BUREAU OF PLANNING AND ZONING

RE: **(24-002 LD) – 24050001 – 2300 City Line Road – Land Development Plan – Ward 13, Zoned CG, plans dated April 26, 2024 last revised July 17, 2024.**

The above-referenced plan has been reviewed by the appropriate City offices. We offer the following comments:

Turning Performance Analysis

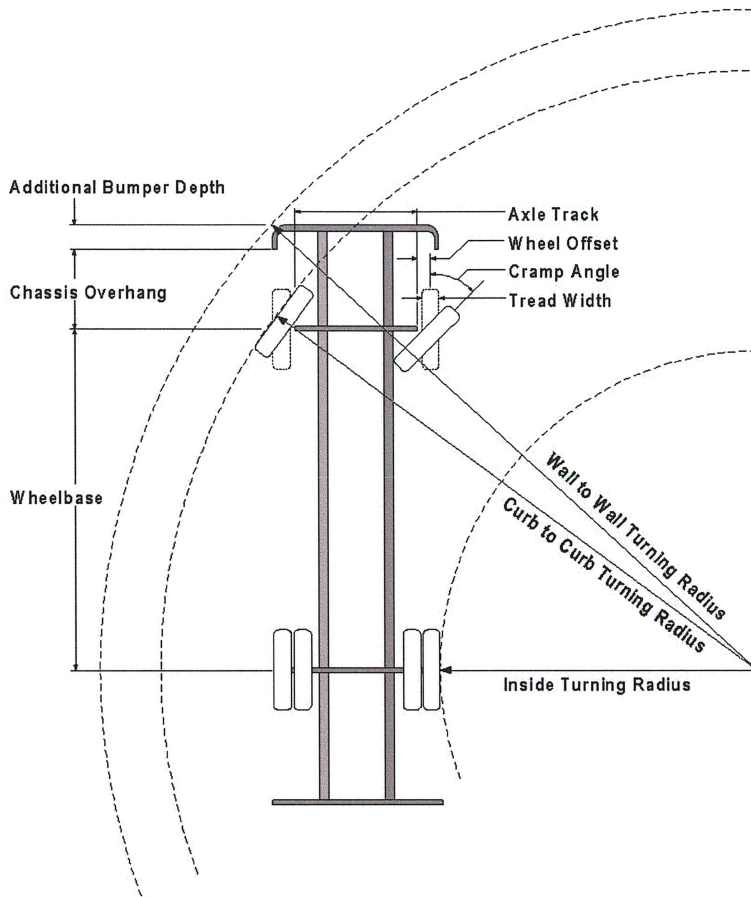
1. Incorrect turn plan data was used to generate Sheet C-905 Fire Truck Turn Plan; Ref. attached Turning Performance Data.
2. Add a note to the plan stating, "Any change in the location of the Fire Department Connection must be approved by the City of Bethlehem Fire Department."

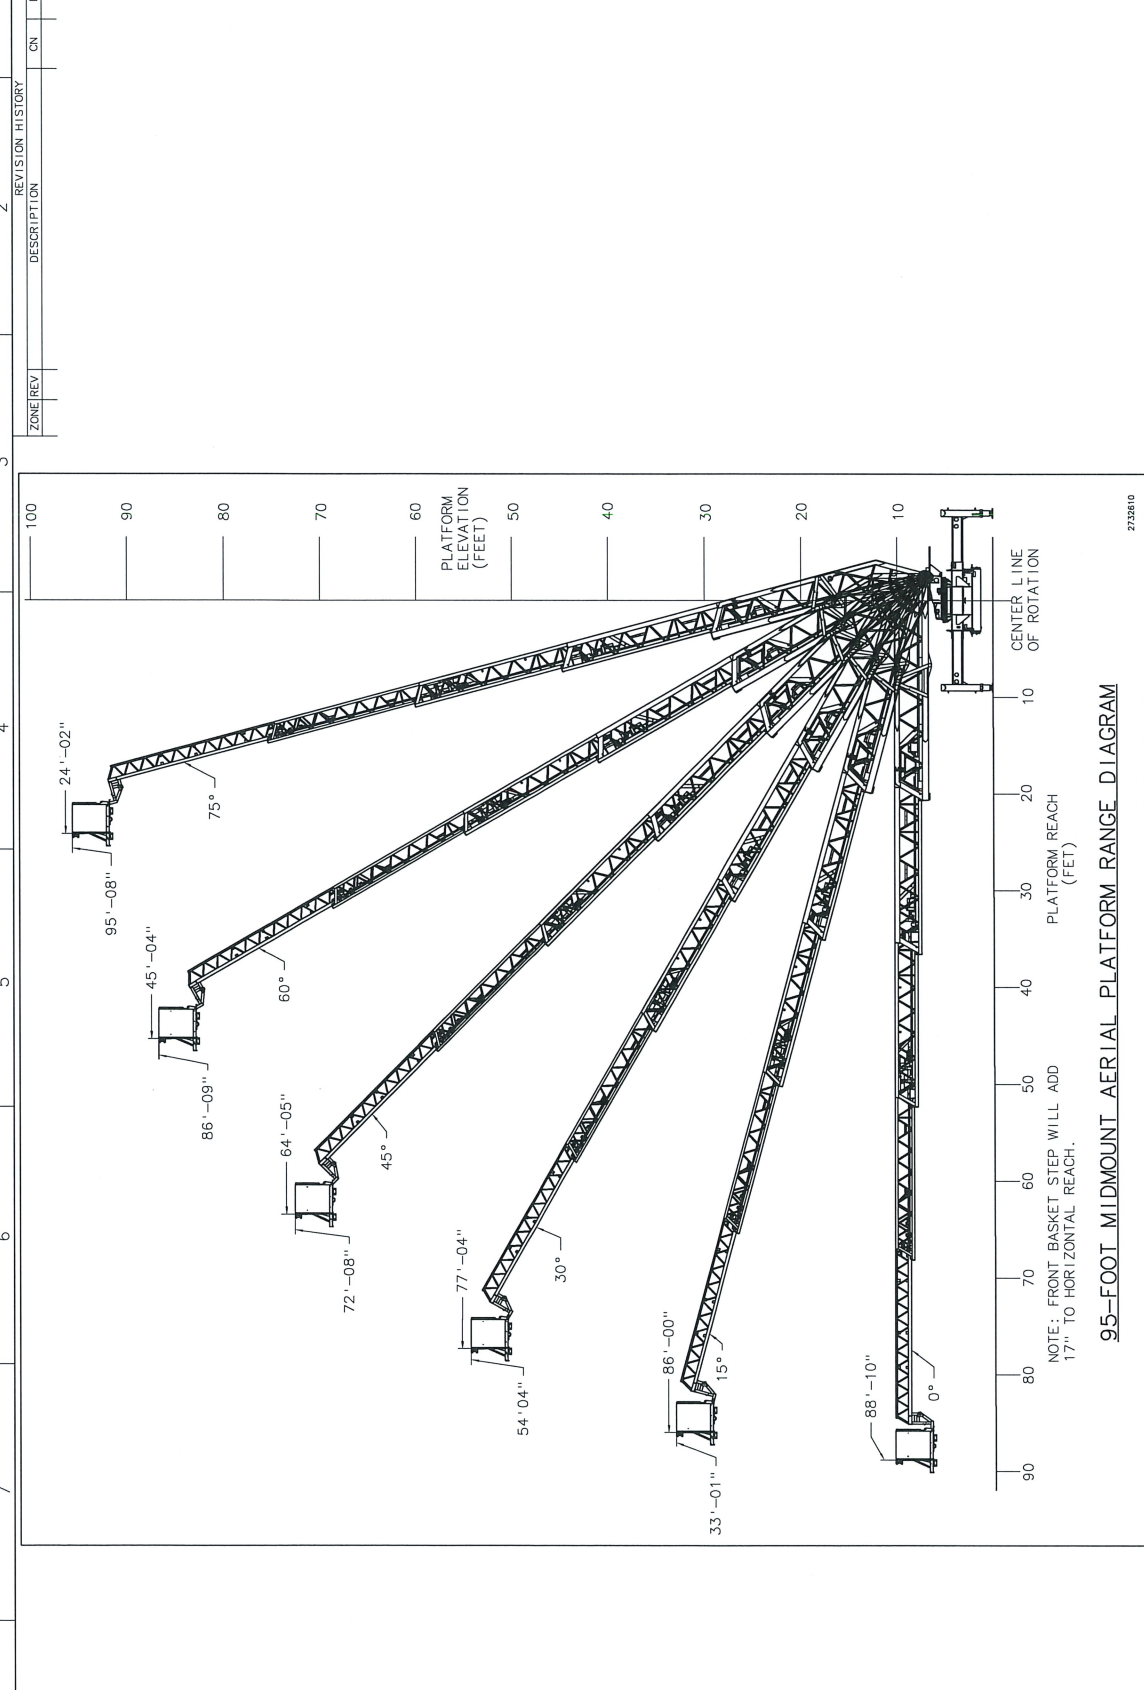
5. Ladder truck access shall be provided along the west side of the building. Provide a plan based upon the attached reach chart showing that the ladder truck will be able to access the roof along this side of the building.

6. Provide reach chart indicating that Fire Department Aerial Apparatus can access the roof of the building over the top of parked tractor trailers.
7. Provide bridge weight rating documentation indicating that the bridge can support #84,000 to meet the requirements of Note 5 above.
